ABERDEEN SECOND ADDITION

TO WICHITA, SEDGWICK COUNTY, KANSAS

RE: S/D 96-18, Final Plat of the ABERDEEN 2ND ADDITION

RE: S/D 96-18, Preliminary Plat of the ABERDEEN 2ND ADDITION

ABERDEEN SECOND ADDITION

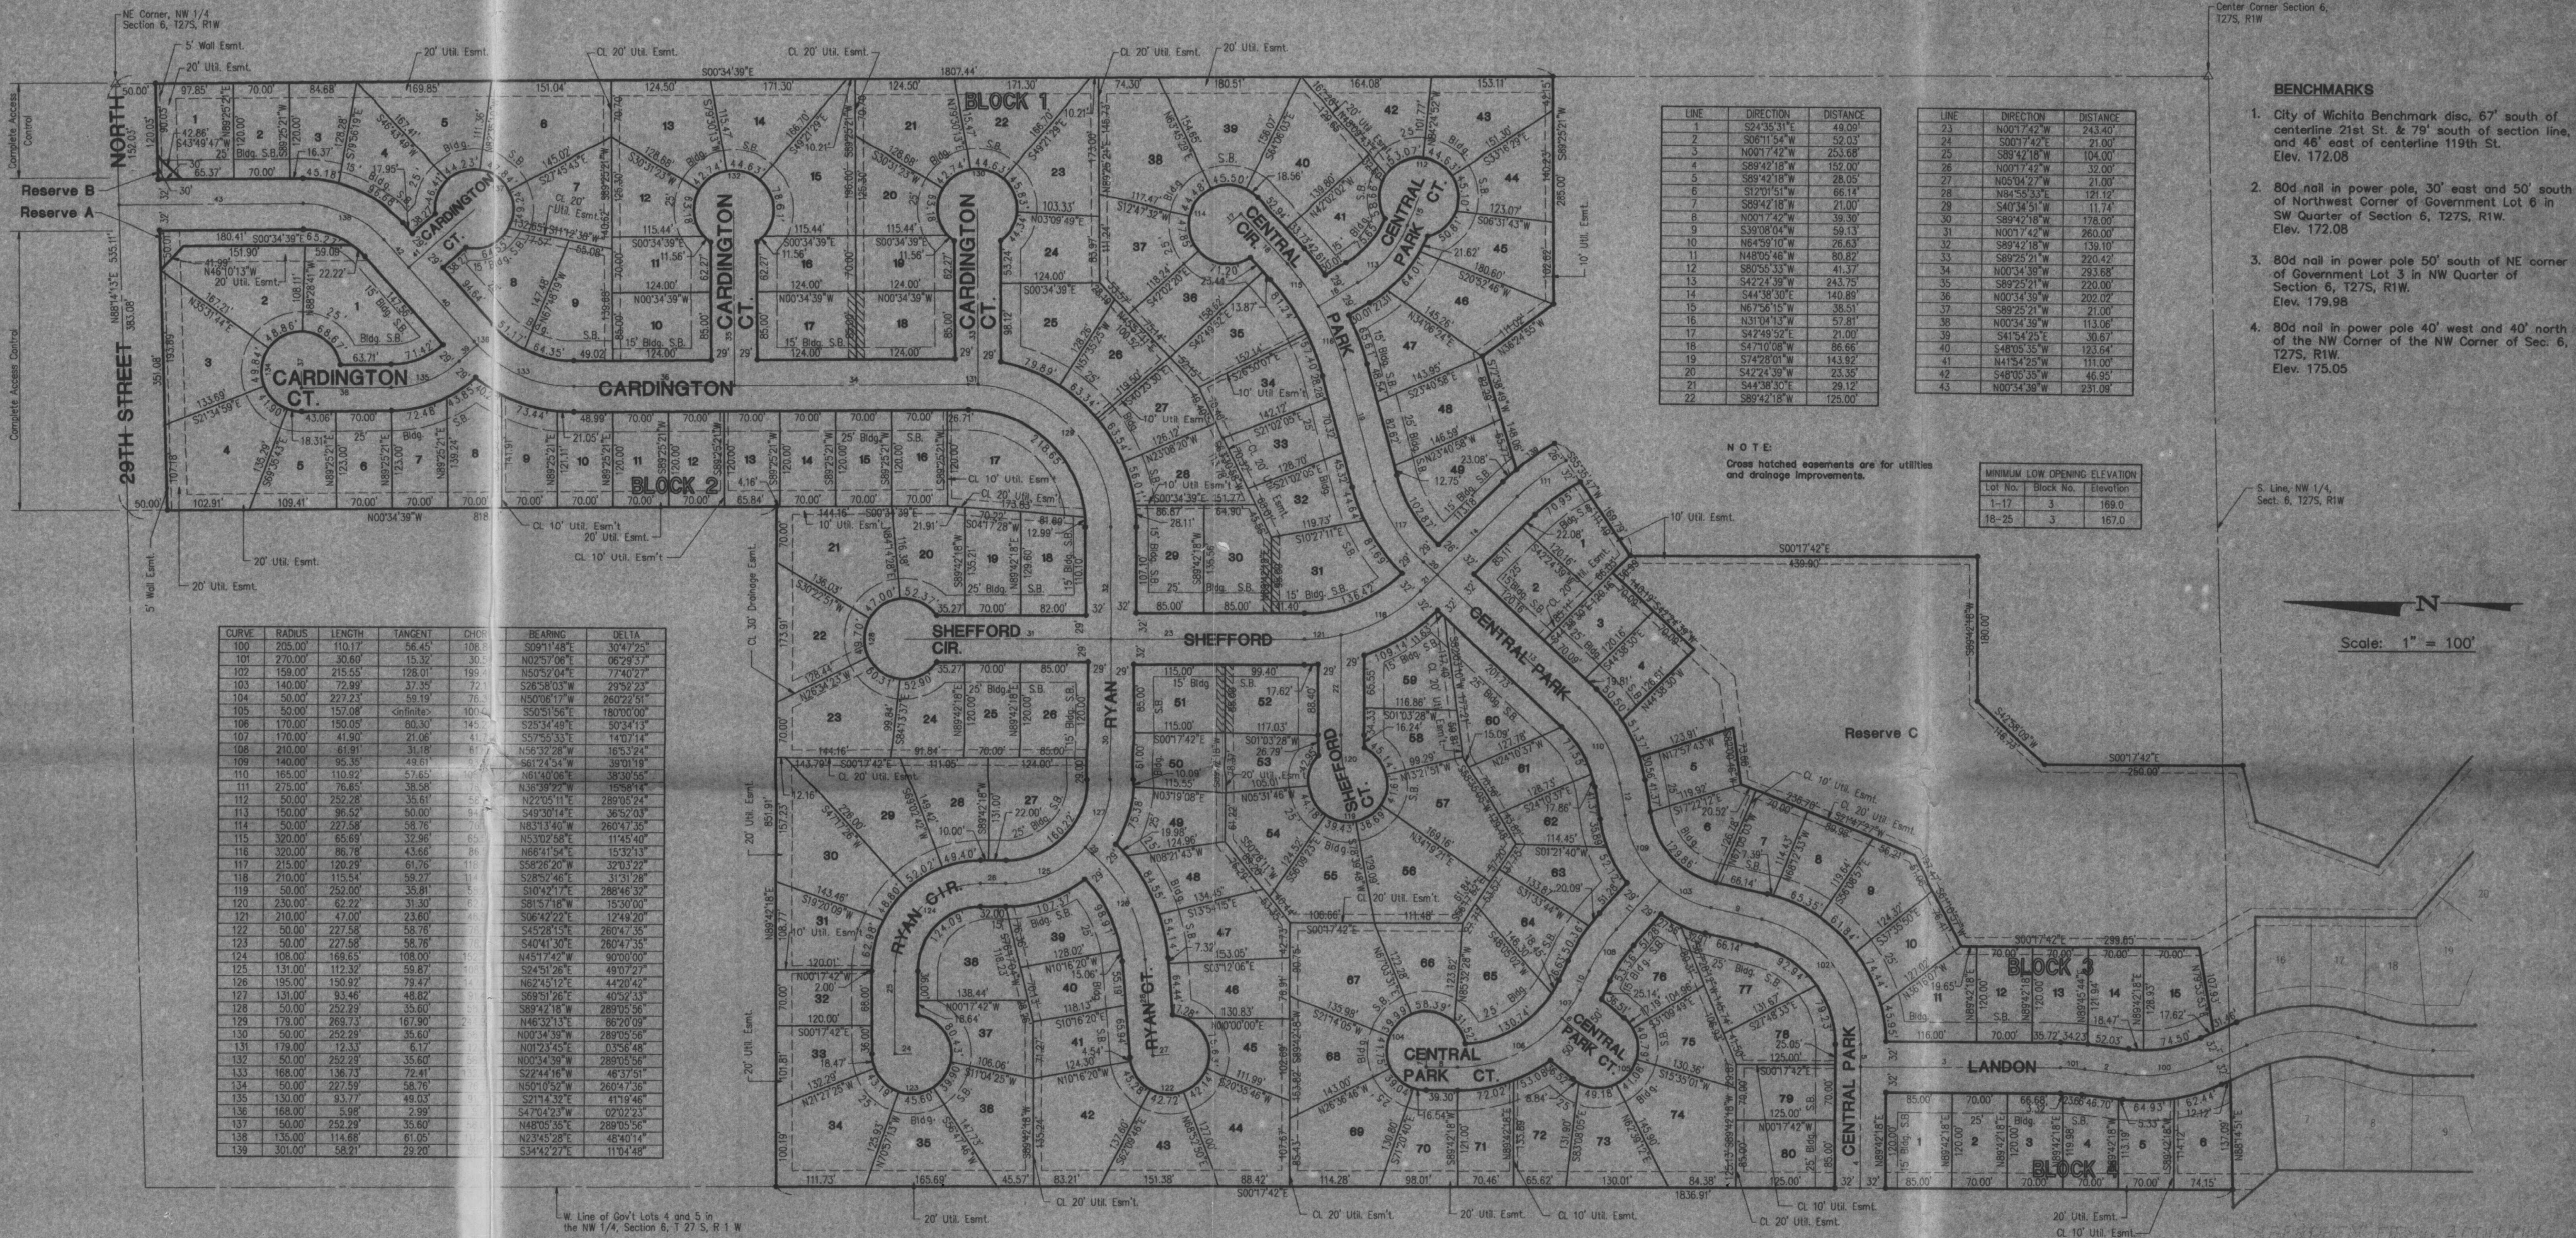
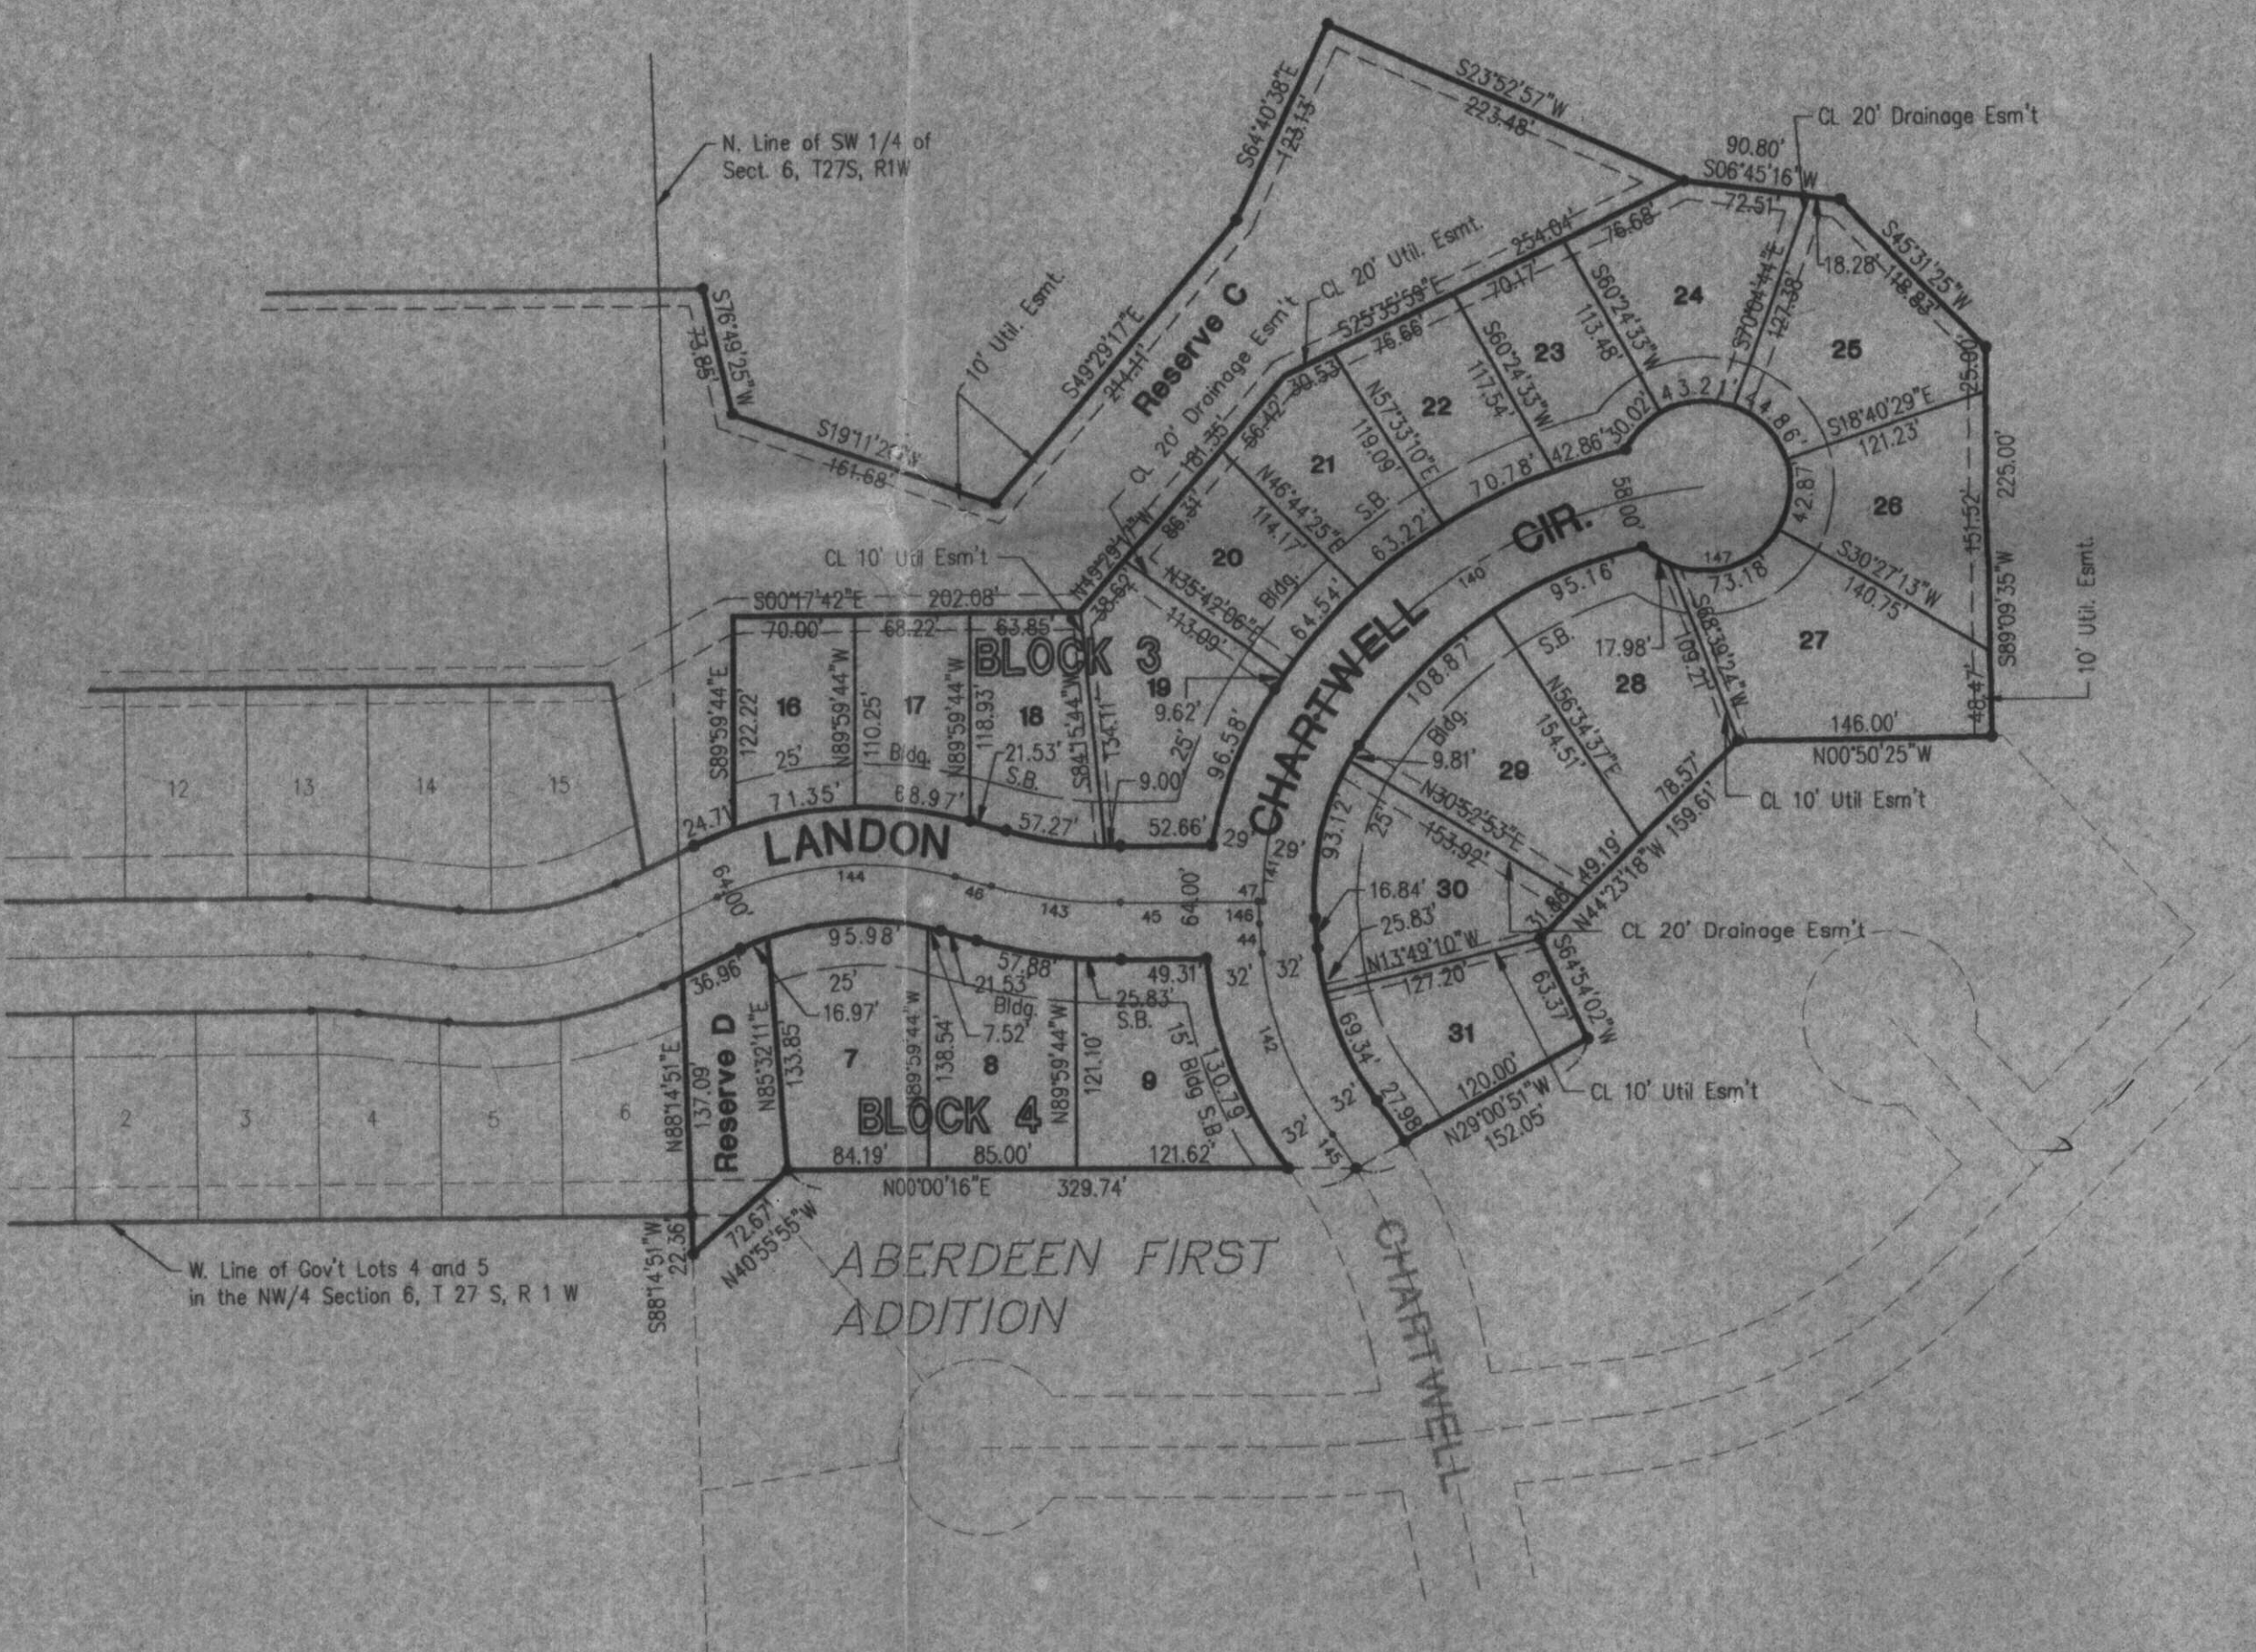
- M. Since this property will need to establish minimum building pad elevations, the face of the plat shall reference the location and elevation of permanent on-site and off-site benchmarks. Section 5-402(N).

- N. The platting of the minimum building pad elevations shall be noted on the face of the final plat tracing as well as in the plat's text.
- O. The applicant shall submit a covenant which provides for four (4) off-street parking spaces per dwelling unit on each lot which abuts a 58-foot street. The covenant shall inventory the affected lots by lot and block number and shall state that the covenant runs with the land and is binding on future owners and assigns.

- Q. On the final plat tracing, as indicated by the platlor's text, a utility easement shall be provided within Reserve B.
- R. On the final plat tracing, dashed lines shall be used where the streets (Chartwell, Central Park, etc.) terminate at this plat's perimeter. Solid lines are used to indicate private streets.

- Y. The final plat shall indicate the utility easements requested by K.G. & E. which are indicated on the enclosed "marked" copy of the plat.
- Z. As noted by City Engineering, prior to submitting the final plat tracing for City Council review, additional information will be needed in regards to this site's drainage plan. Also, the applicant shall confirm if this site is impacted by high ground water levels and if necessary building pad elevations will be required for any such lots.

- Q. On the final plat tracing, as indicated by the plat's text, a utility easement shall be provided within Reserve B.
- R. On the final plat tracing, dashed lines shall be used where the streets (Chartwell, Central Park, etc.) terminate at this plat's perimeter. Solid lines are used to indicate private streets.
